As I mentioned this morning, a discussion yesterday with other residents and an architect friend has yielded two suggestions for reducing the height and 'block' of the boathouse facing Riverside (but without reducing internal volume or uses). We would be very grateful if you could discuss these with the Colleges to see whether they are willing to consider them. To reiterate our position NO resident is opposed to boathouse use on this site, or to redevelopment to improve facilities including a second storey. And most residents agree that the materials and overall 'look & feel' of the building are stylish and attractive.

ONE SIMPLE SOLUTION TO REDUCE 'BLOCK' HEIGHT FACING RIVERSIDE?

SUGGESTION 2:  
ROTATE FIRST FLOOR  
& RECONFIGURE  
INTERNAL USES SO VARIED

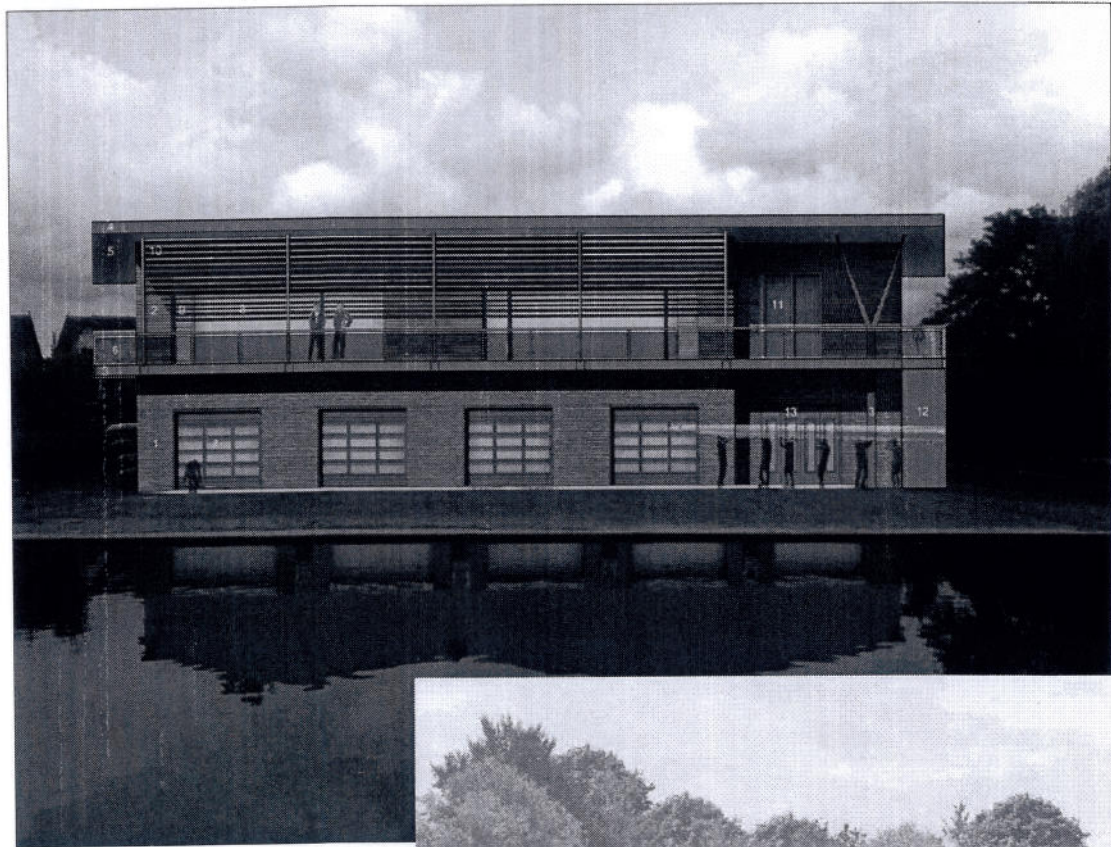
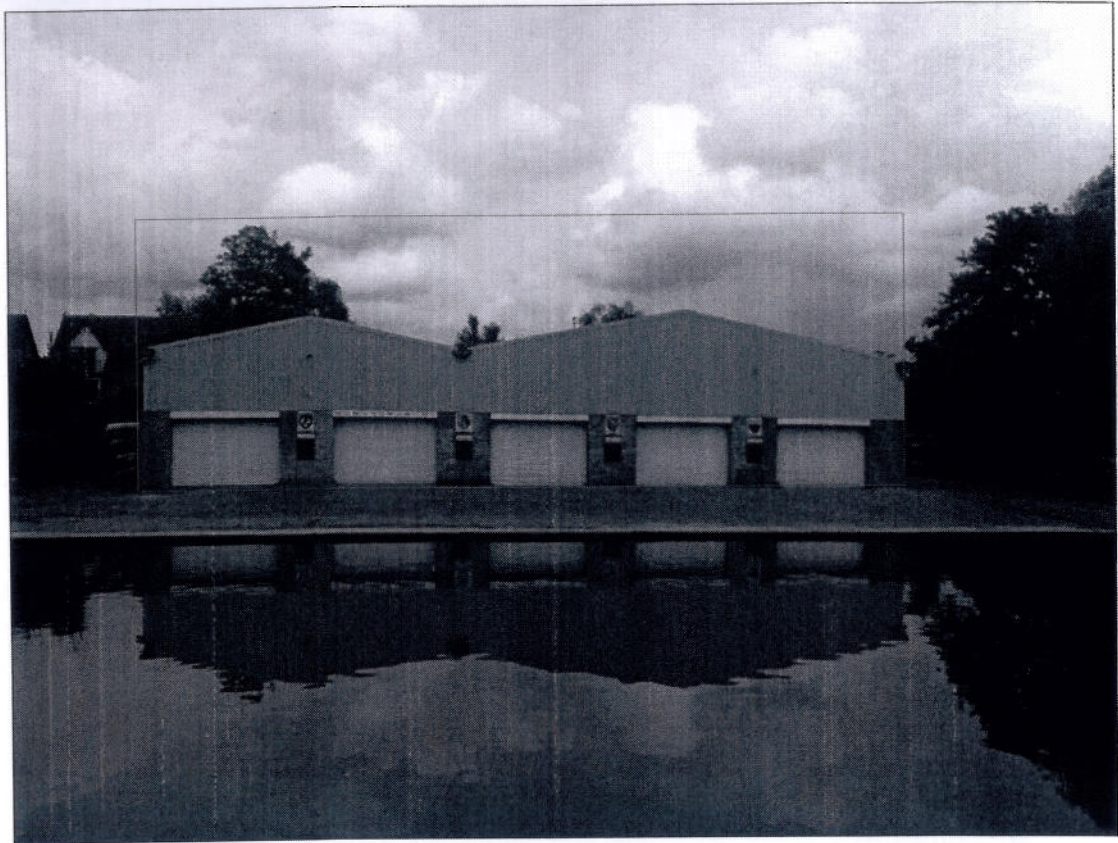
This suggestion would involve a bigger rethink of first floor layout and roof, but has the potential to transform the impact of the building on the river frontage. It could also reduce the bulk facing Capstan Close residents if the roof line dropped rather than rose to the west (as shown). At present, with the design submitted, all roof interest runs north-south and would be totally obscured by large flanking trees to east and west. PLEASE NOTE that the applicants' key visual is unfortunately very misleading on this point - the willow is far closer to the boathouse in reality than shown - see 'Riverside view 2' attached).

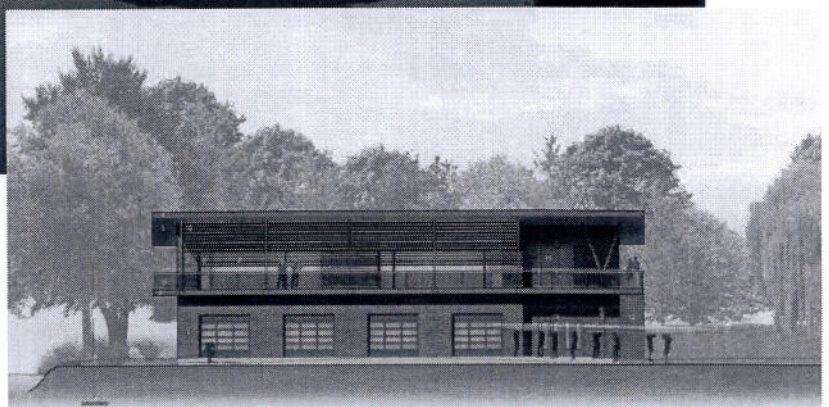
This is the picture in the proposal. Note the non-existent 20m high tree!

SECTION C-C

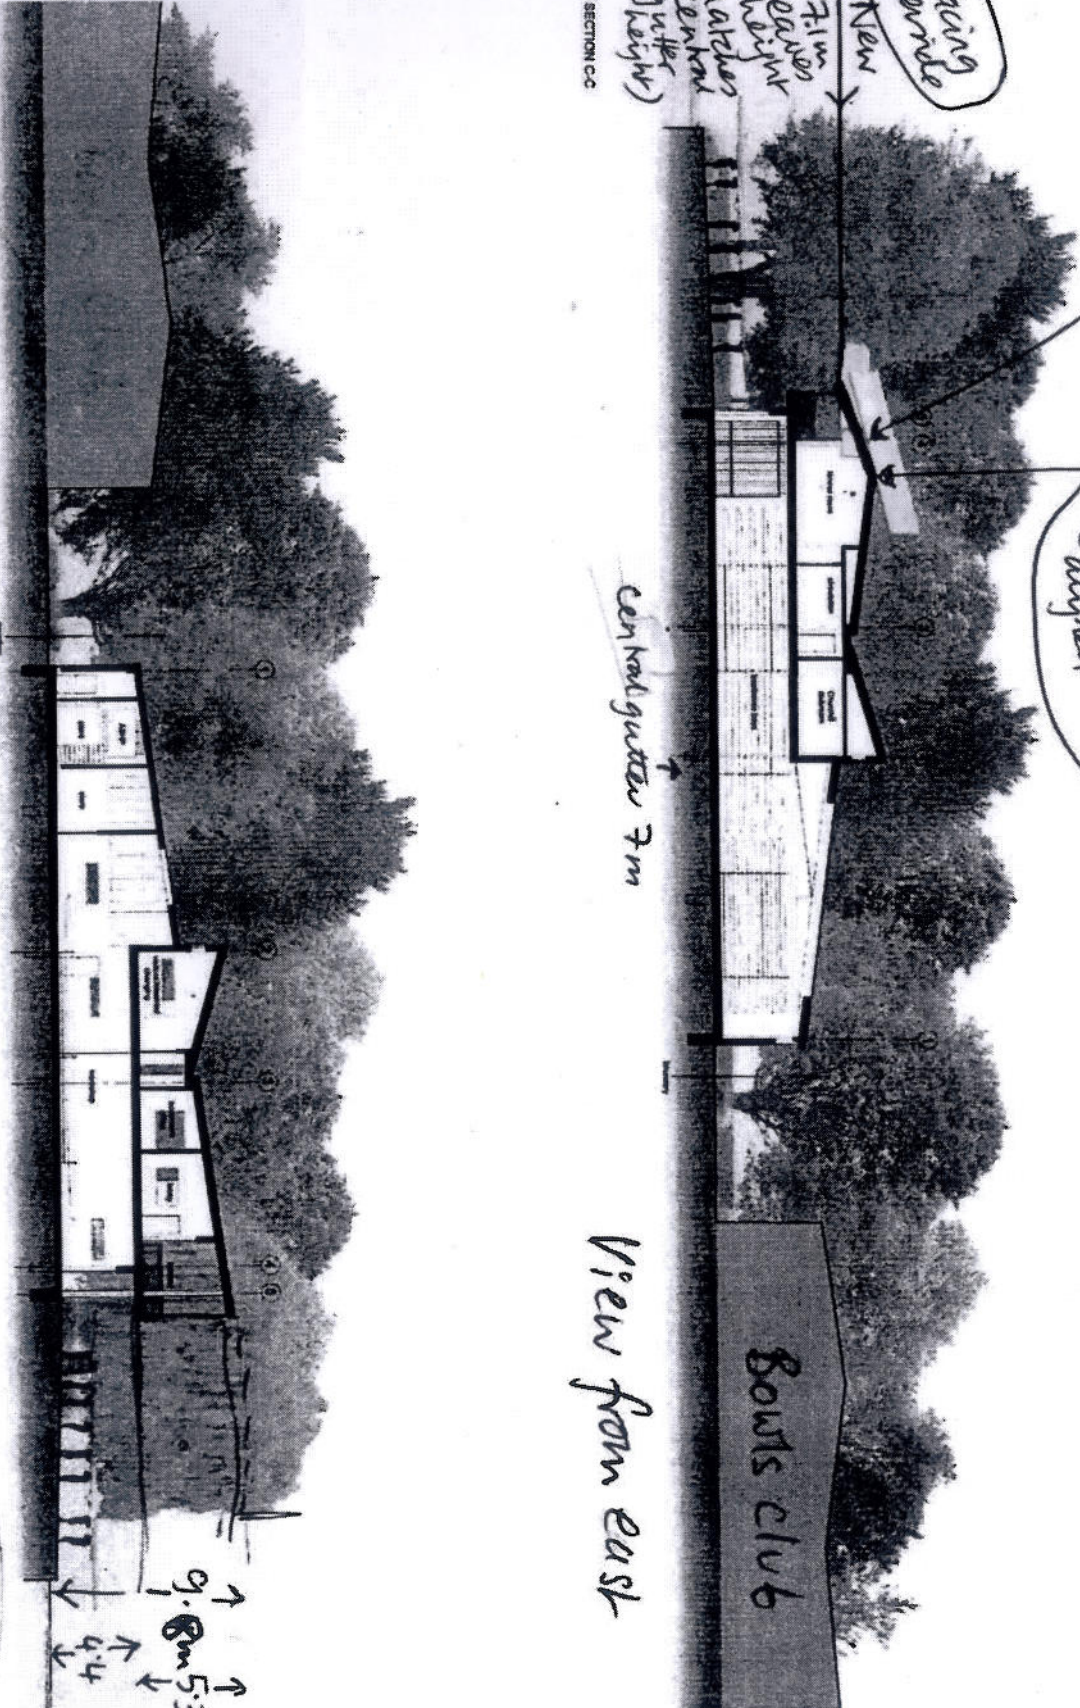
1. Change the roof structure over the fitness room and lobby, adding a ridgeline running east-west halfway back. The roof would then drop down to Riverside instead of continuing to rise, with eaves height approx 7m rather than nearly 10m. See annotated drawing (Height reduction idea 001). Internal floorspace and functions would be unchanged. The balcony could still run the full length of the building but would be c2.7-3m high instead of 5.3m

new pitched roof

Add new ridge line here (ear-vest) aligned

central gutter 7m

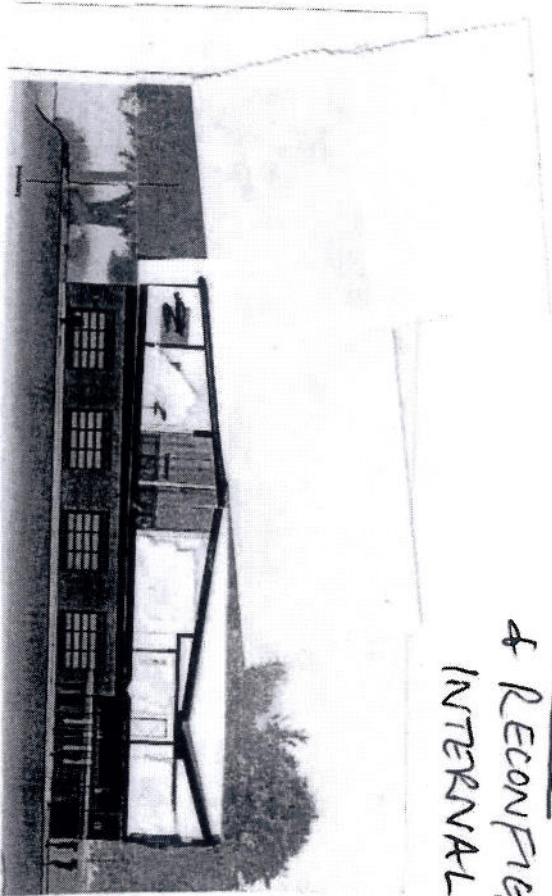
2. An alternative, more creative solution would be to 'rotate' the first floor so the interesting assymetric roofscape runs east-west to face the river. This would break up the skyline when viewed from Riverside, and

complement local pitched roofs on both north and south banks of the Conservation Area. Internal first floor layout would need to be reconfigured to keep fitness room and balcony at the front, but ground floor layout would remain exactly the same. The attached file (Height reduction idea 2) attempts in a very rough and ready way to illustrate this suggestion, though actual roof arrangement would depend on internal reconfiguration.

ROOFLINE INTERE  
FACES RIVERSIDE  
& BREAKS UP

→ E.G.  
(ILLUSTRATIVE)  
- BALCONY COULD  
STILL RUN  
ALONG FRONTAGE  
WITH FIVE  
ROOM BEHIND
